Object: revision of guideline 1/29

Guideline 1/29
Pressure equipment directive 97/23/EC
Commission's Working Group "Pressure"
Guideline related to: Article 1 Paragraph 3.1
Question:

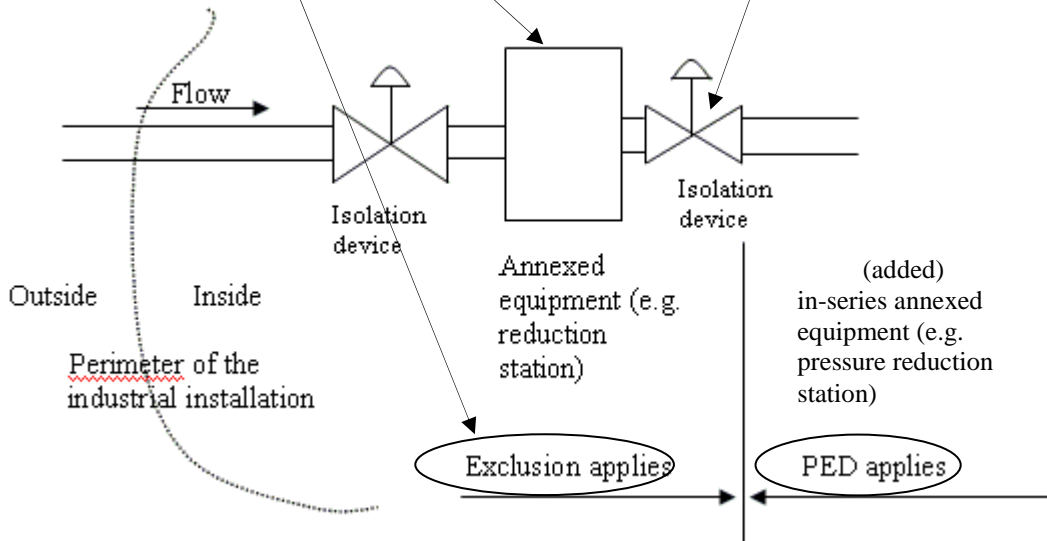
There are some discrepancies between the text and the diagram of the guideline 1/29 accepted by Working Group “pressure” on 28 June 2005 e.g.

- The text of answer a) is not coherent with the diagram, because the exclusion ends at the **outlet** isolation valve of the annexed equipment fed by the distribution / transmission pipeline (the diagram show two isolation valves inside the perimeter of industrial installation; which one is the “isolation device immediately inside the perimeter of the industrial installation?”)

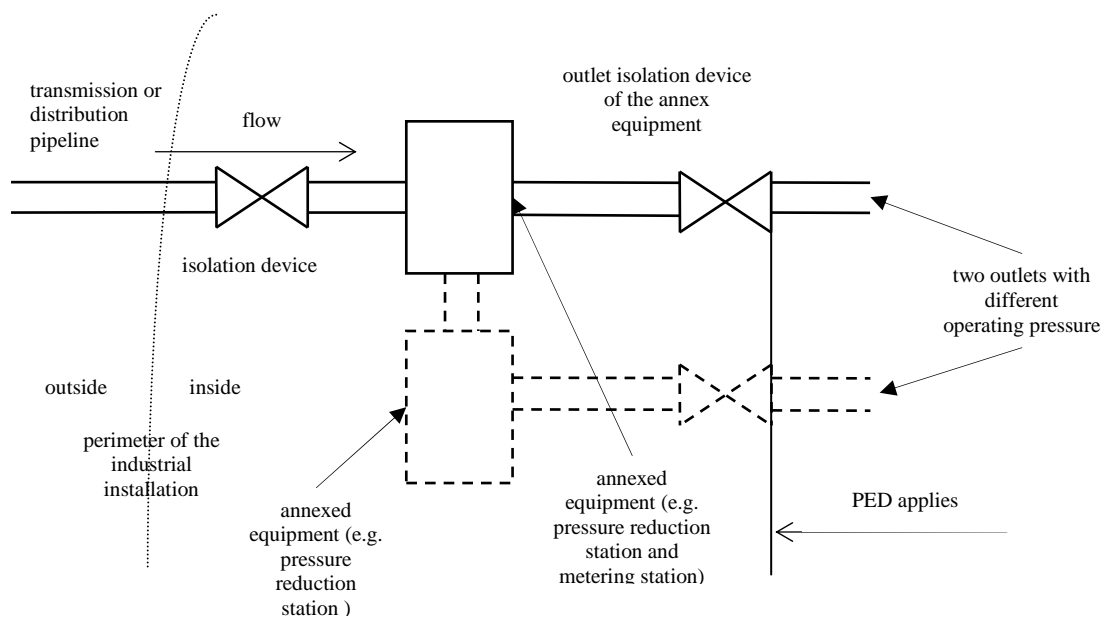
To avoid any misunderstanding it is suggested to amend the guideline as follows

The exclusion of Article. 1, paragraph 3.1 ends at the outlet isolation device of the annexed equipment (e.g. pressure reduction station, metering station supplying gas to the industrial installation) fed by transmission or distribution pipeline.

Note 1: the single or "in-series" compressor / reduction / metering stations (annexed equipment) upstream from the outlet isolation device detailed above are not covered by PED because of, as whole functional unit, they comply with both the Guideline 1/28 and Guideline 1/17

Note 2: the installation beyond the outlet isolation device detailed above is covered by PED; this includes any pressure equipment, any pipework between individual operating units or plants, or storage facilities
